## PIC6461 Information on the Elimination of the Rear Compartment Lock Cylinder

Brand:	Model:	Model Years:	VIN:		Engine:	Transmissions:
			from	to		
Chevrolet	Corvette	2020 - 2023	All	All	All	All

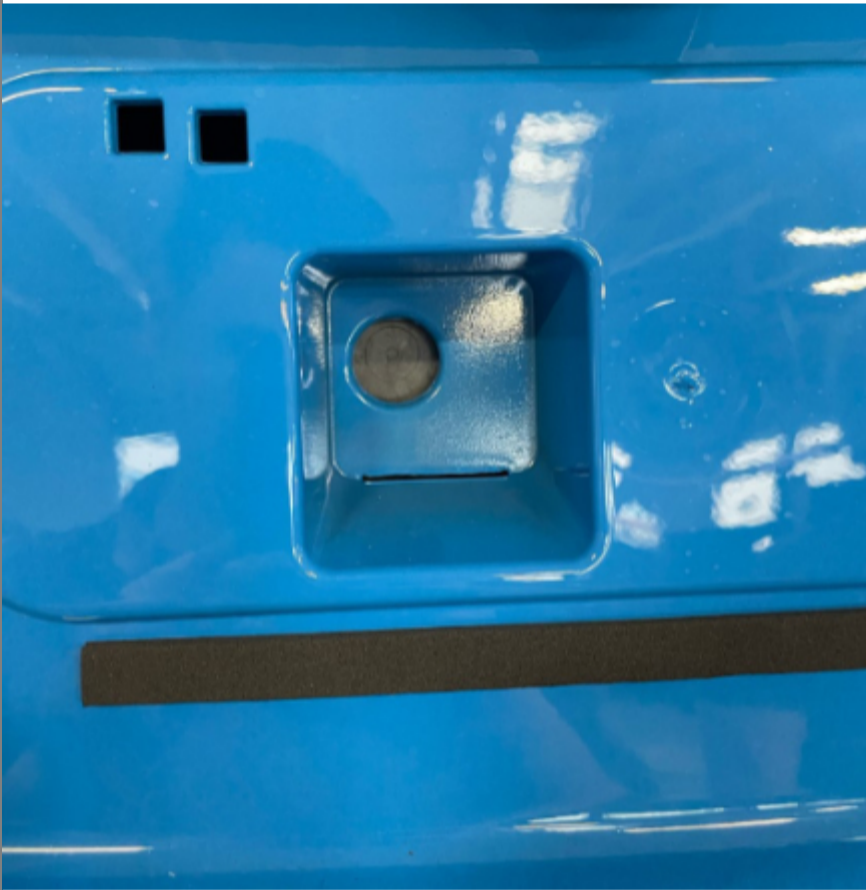
Concern	Starting with the 2023 model year, the rear access lock cylinder has been eliminated from all Corvette models. This lock cylinder will only be found on 2020-2022 model year vehicles. The rear fascias still have the provision for the feature, but there is no cylinder installed, as seen in the photo below.
---------	---

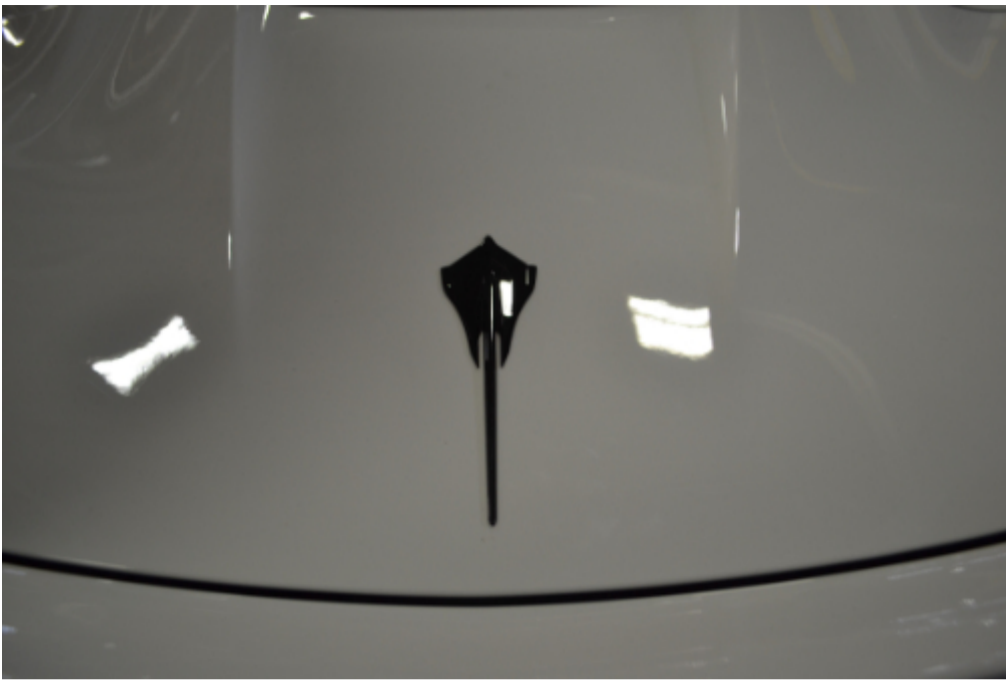
through an access hole in the rear fascia. In the photos below, the lock cylinder can be seen, as well as how to insert the mechanical key, which is housed in the key fob.

Remove the key shank from the key fob, insert it into the lock cylinder, and rotate. This should mechanically release the rear hatch / rear compartment. If access is still not gained through the back up mechanical method, see the section later in this document titled, "Accessing the rear hatch / rear compartment with a seized up latch."
